Long Island Rail Road

General Notice No. 3-1

General Notice 3-1 contains information related to and supersedes General Notices 2-59 through 2-69. General Notices 2-59 through 2-69 are to be discarded.

Effective 12:01 AM Monday, May 22, 2017

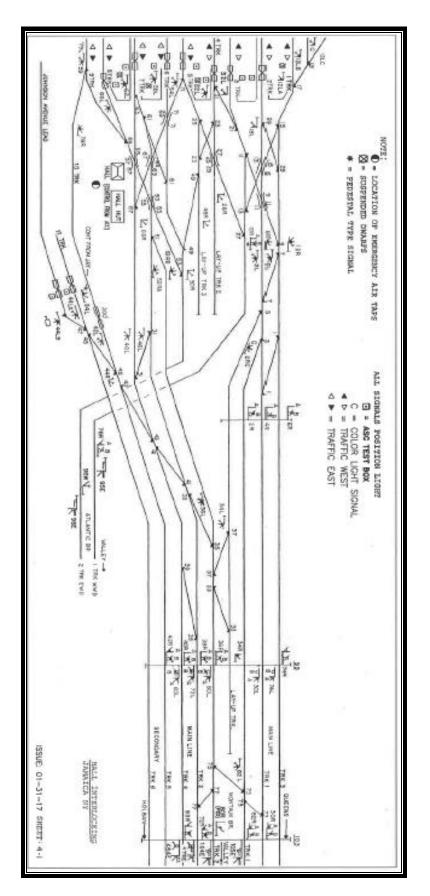
Atlantic – Eastward Atlantic Freight Track

Due to Jamaica reconfiguration work, the Eastward Atlantic Freight track has been removed from service. Signal 10LB Dunton Interlocking and signal 96RB Jay Interlocking have been removed from service and 9 switch Dunton Interlocking formally located first facing point switch east of 10R signal Dunton Interlocking on Atlantic 4 track has been removed from service.

See diagram attached to and part of this General Notice.

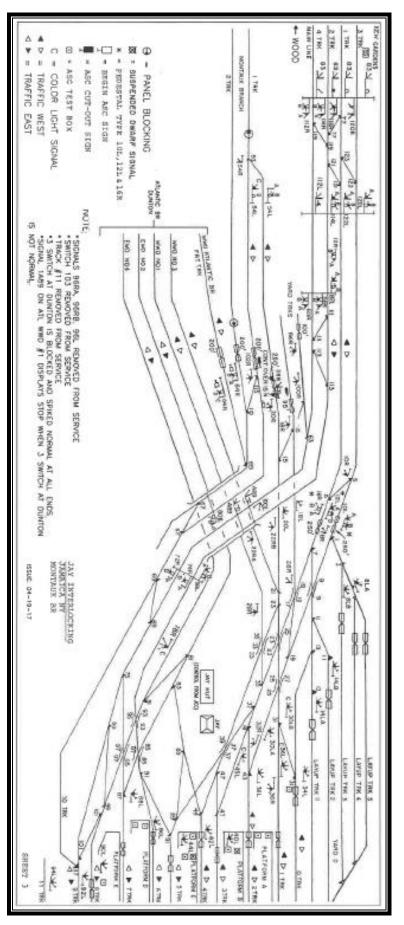
(C) Entire Railroad Operations Manual - Appendix G Hillside Yard Map

Employees must make the following change in ink: Place an "X" through the Hillside Yard map and add, "See General Notice 3-1, Page 10".

Physical Characteristics Hillside Yard

7 track: Eastbound facing point automatic safety switch (crossover switch to Transfer A track) along with the crossover have been removed.

Transfer A track: Eastbound trailing point automatic safety switch (crossover switch from 7 track) along with the crossover have been removed.
